GULF STATES UTILITIES COMPANY

River Bend Station - Unit 1
Docket No. 50-458

Enclosed for your review is Gulf States Utilities Company (GSU) supplemental response to the request for additional information dated June 13, 1984 from the Nuclear Regulatory Commission (NRC) Staff regarding the status of corrective action on five recent 10CFR21 notices issued by Transamerica Delaval, Inc. (TDI). Enclosure 1 summarizes each GSU Deficiency Report (DR) while the attachments contain copies of the GSU responses previously provided.

GSU Deficiency Report (DR) No. 298, "Air Start Check Valves"

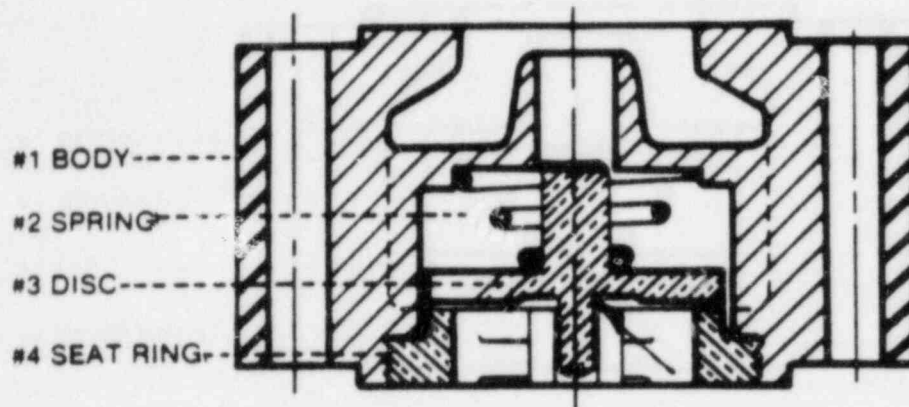
In the mean time, our recommendation for corrective action is to disassemble the Check Valves on the Engine and inspect the Disk Guide for cracks (LPI). Attached is a copy of the assembly drawing of this Valve showing the area of concern.
